## SINGAPOREAN NOTICES TO MARINERS

The monthly Notices to Mariners contain information required to keep charts and publications published by the Hydrographic Department, Maritime and Port Authority of Singapore up-to-date.

CORRECTION NO.	SNM EDN NO.	LAST CORRNO NO.	CHART NO.	Location on Chart
<b>102 (Sheet 4)</b>	<b>11/2017</b>	<b>99/2017</b>	<b>501</b>	X

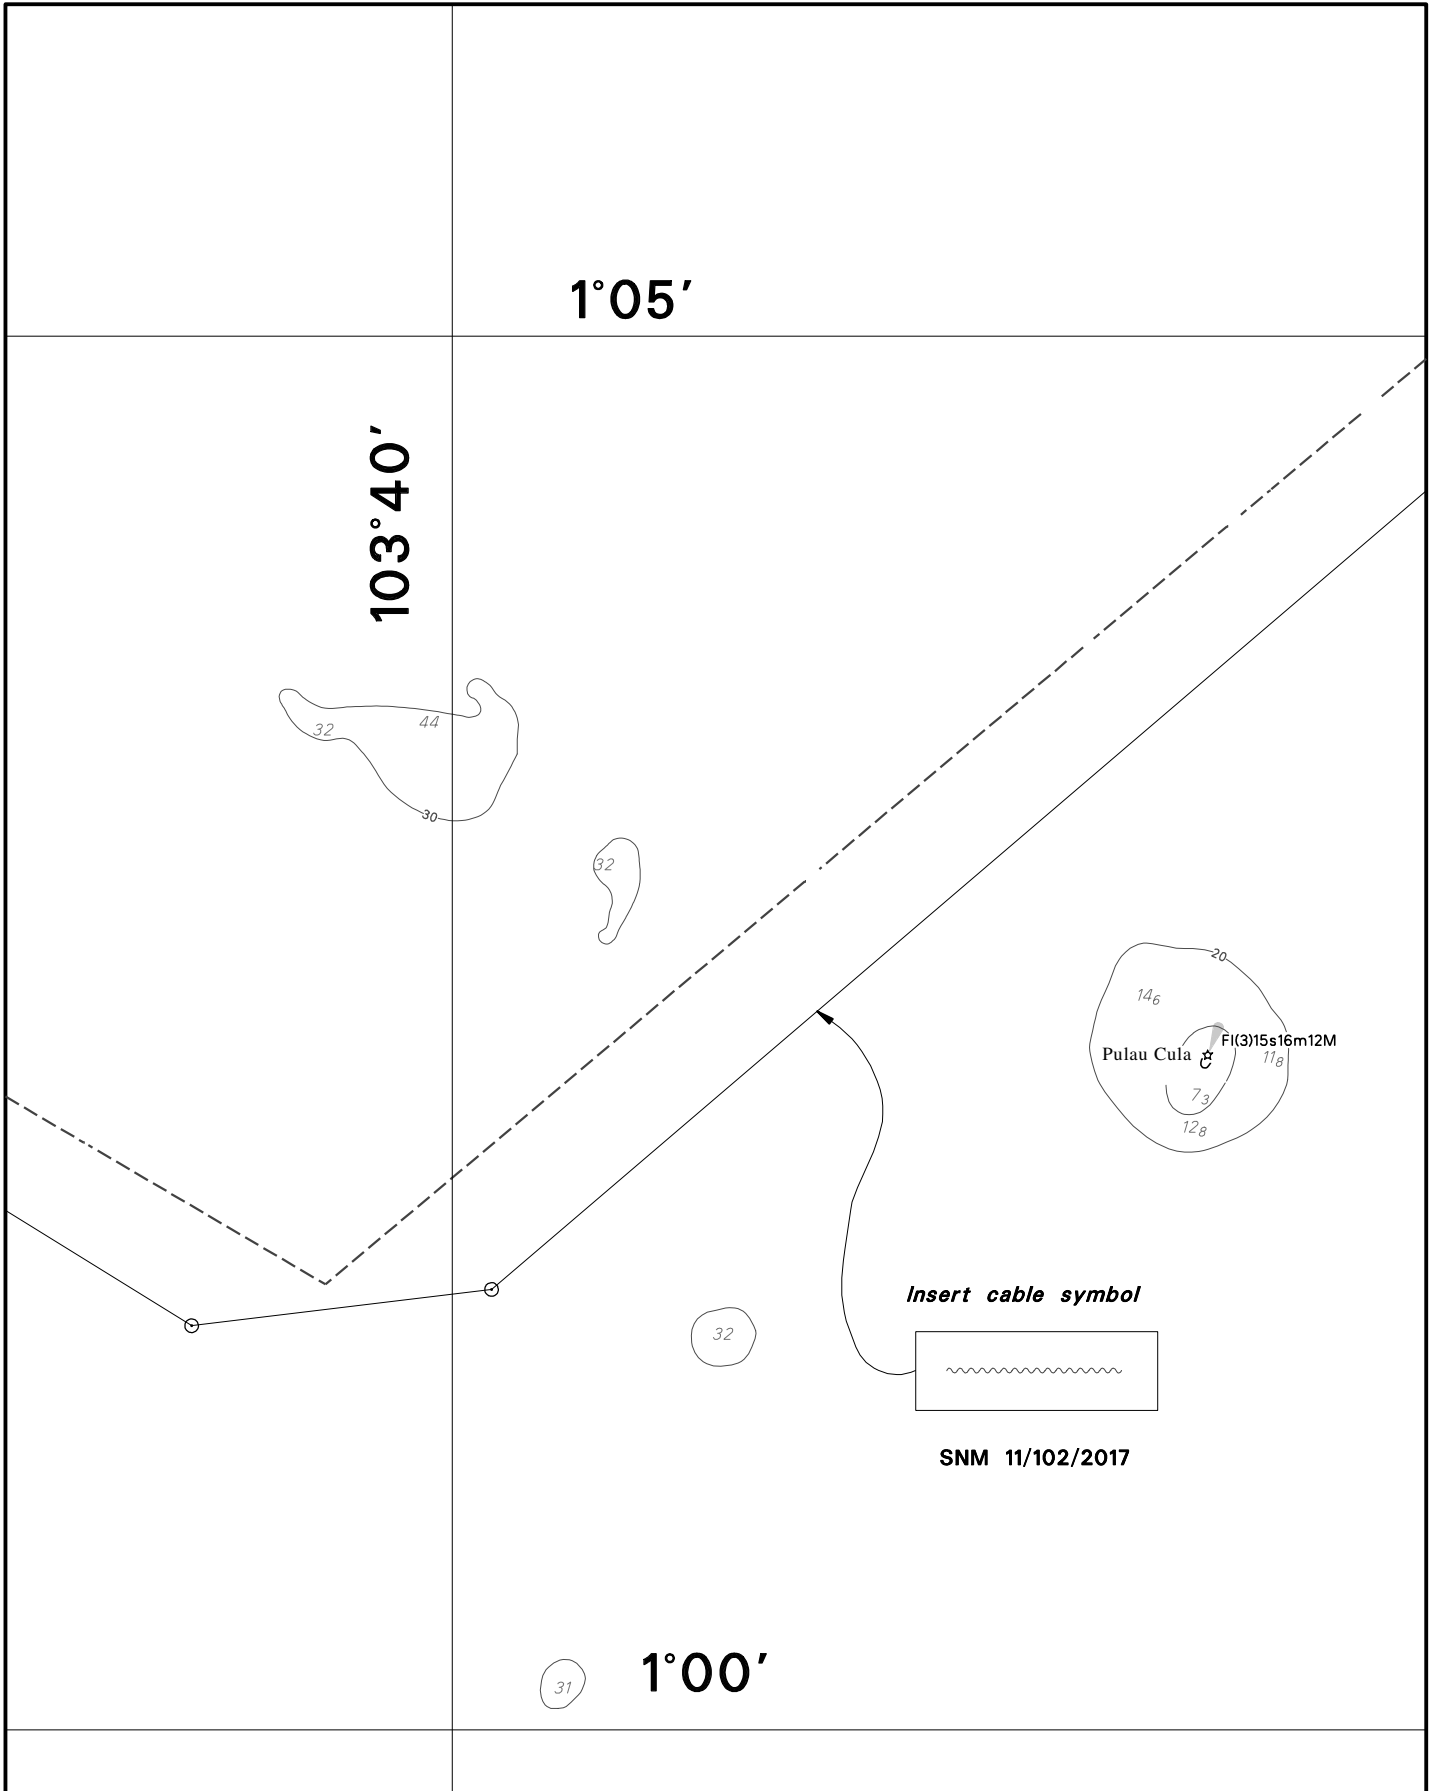
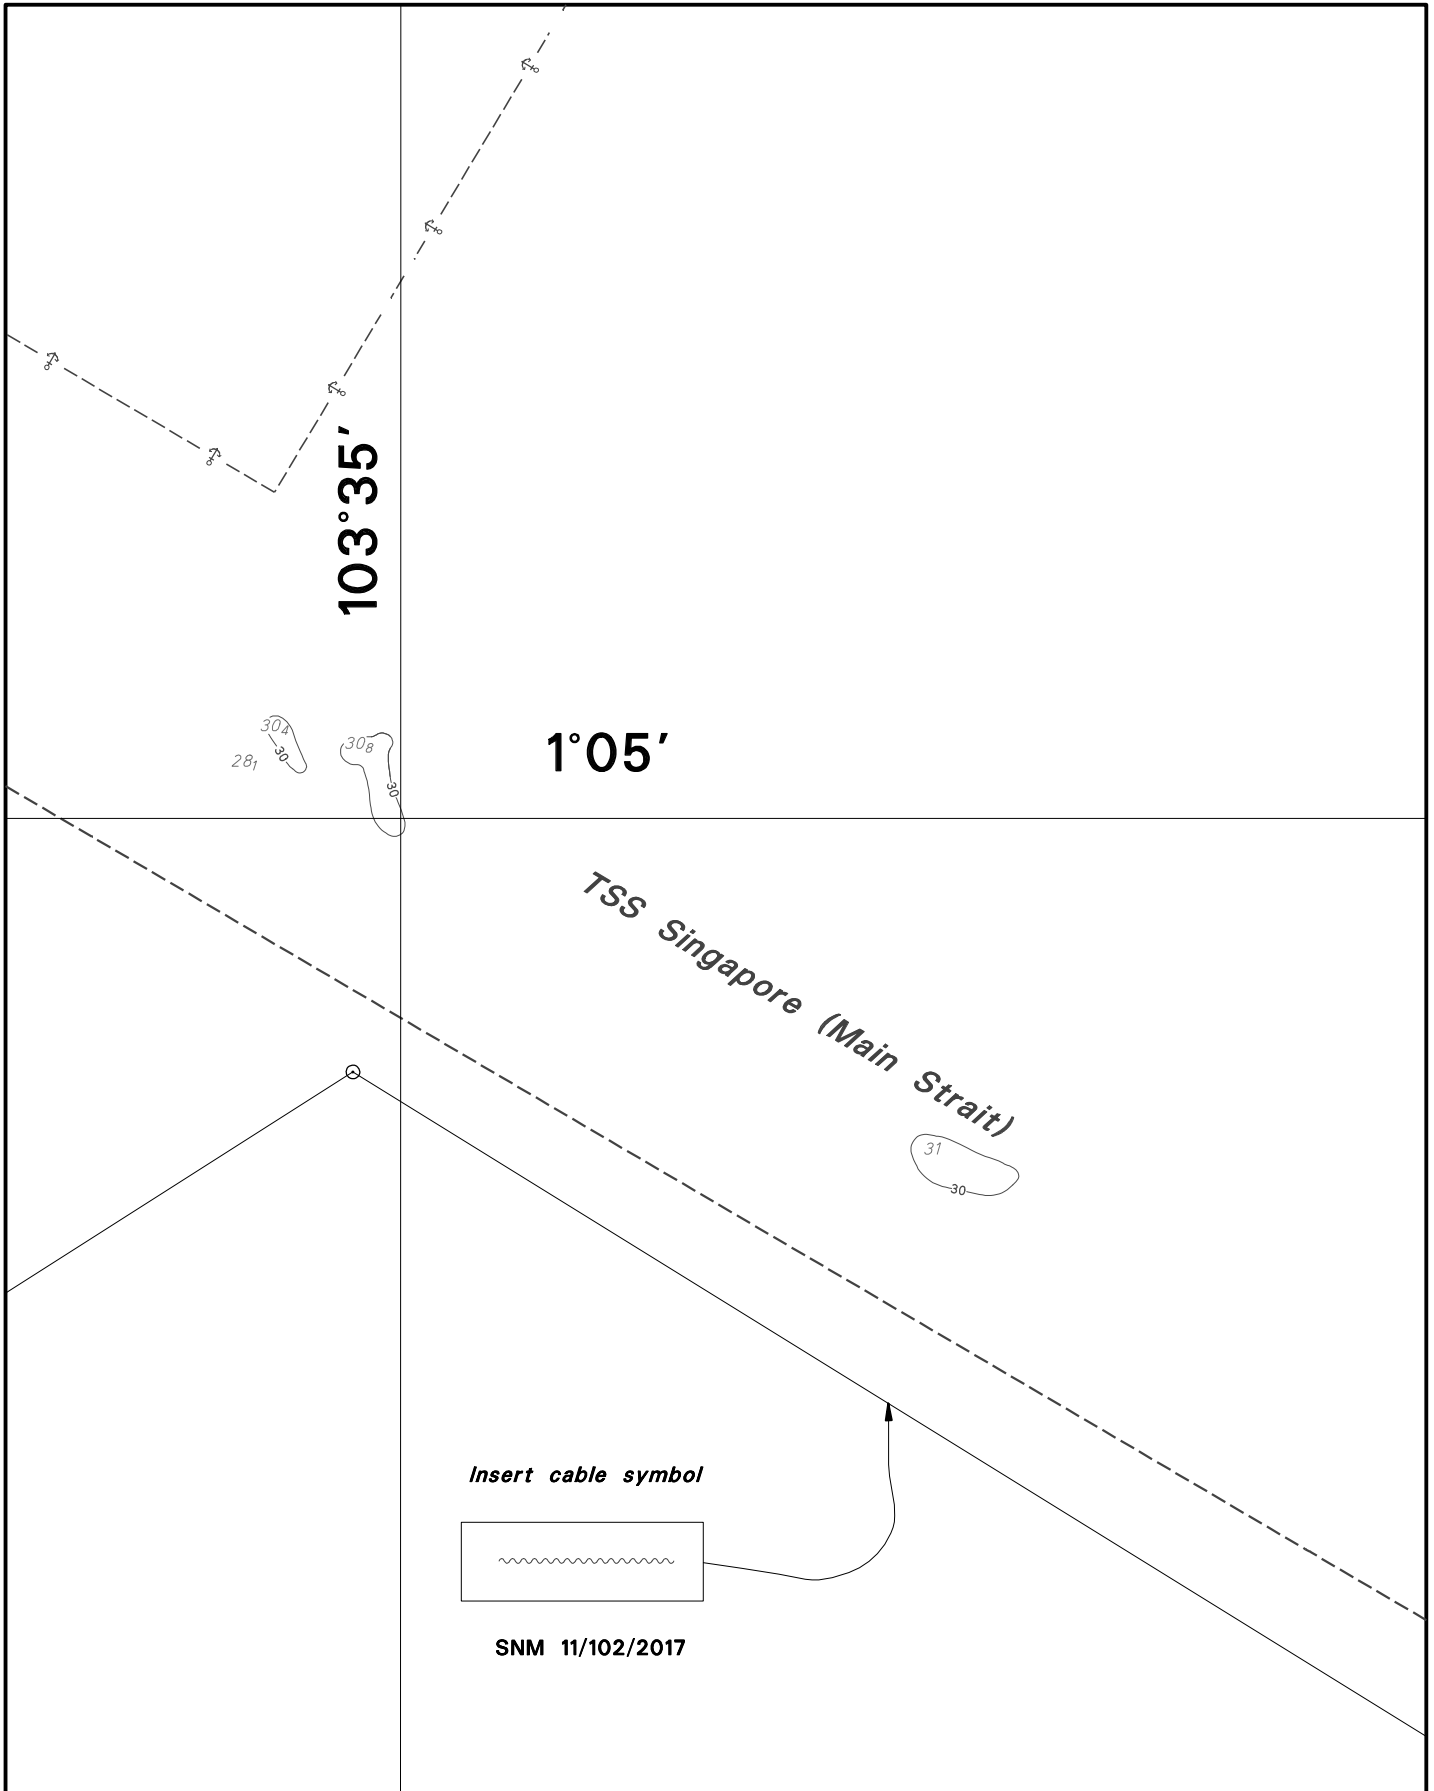
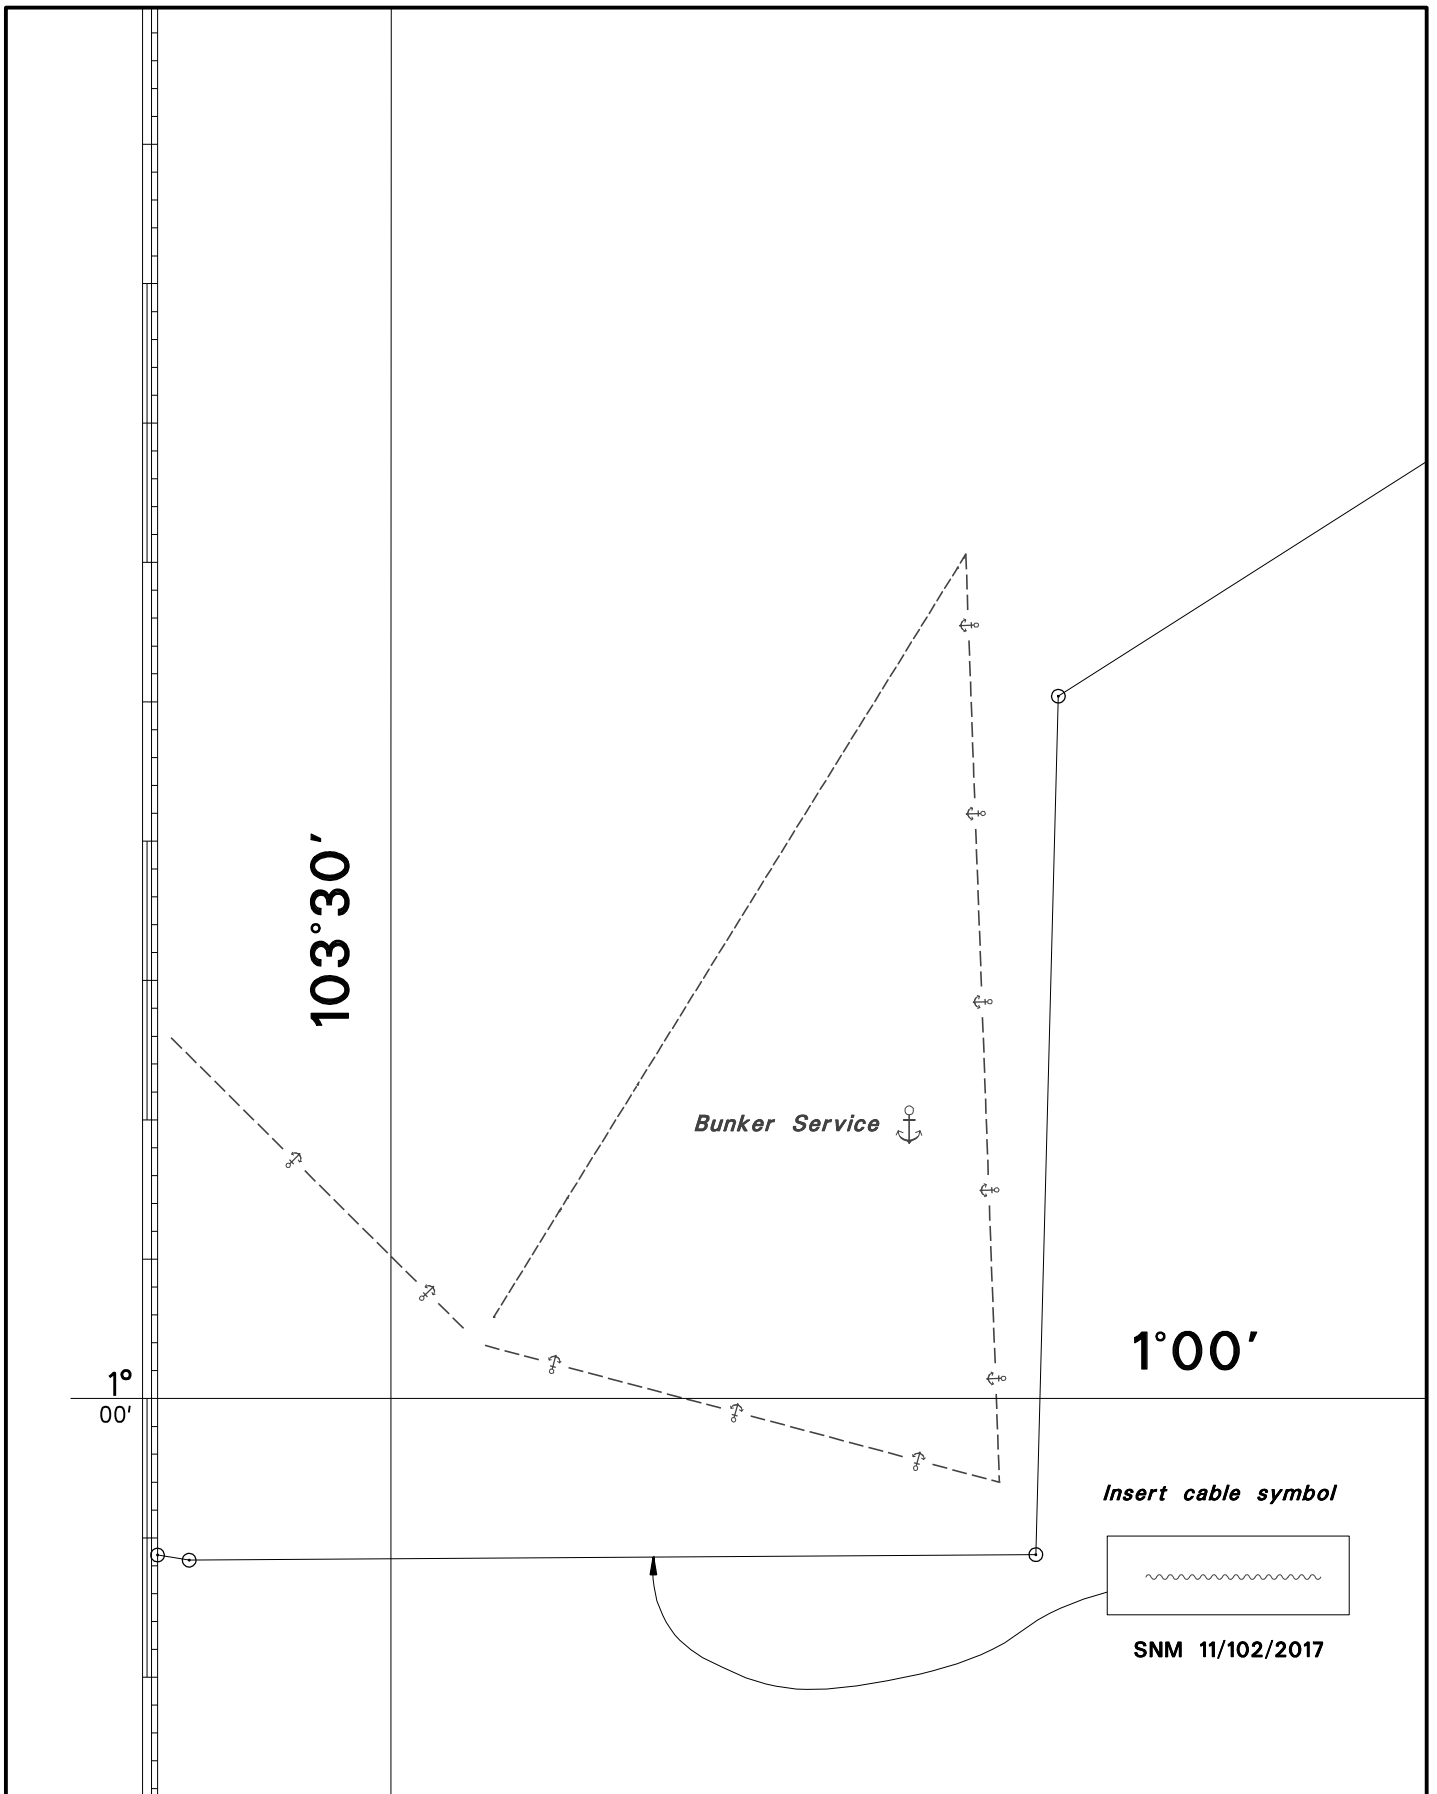
<b>502</b>	7 Ed 1/09/15 Last NM 88/2017	(Indonesian Notice No. 36/552/17)	<b>NM 102/2017</b>
<b>Insert</b>	submarine cable,  , joining :		
		1°08·59'N	103°55·31'E
		(shore)	
		1°08·95'N	103°55·28'E
		1°09·87'N	103°54·30'E
		1°10·54'N	103°54·28'E
		1°10·83'N	103°53·02'E
		1°10·38'N	103°51·51'E
		1°10·21'N	103°51·43'E
		(chart border)	
-----			
<b>503</b>	5 Ed 15/08/14 Last NM 94/2017	(Maritime and Port Authority of Singapore)	<b>NM 103/2017</b>
<b>Insert</b>	Automatic Identification System, <b>AIS</b> , on lighthouse		
		1°19·81'N	104°24·34'E
-----
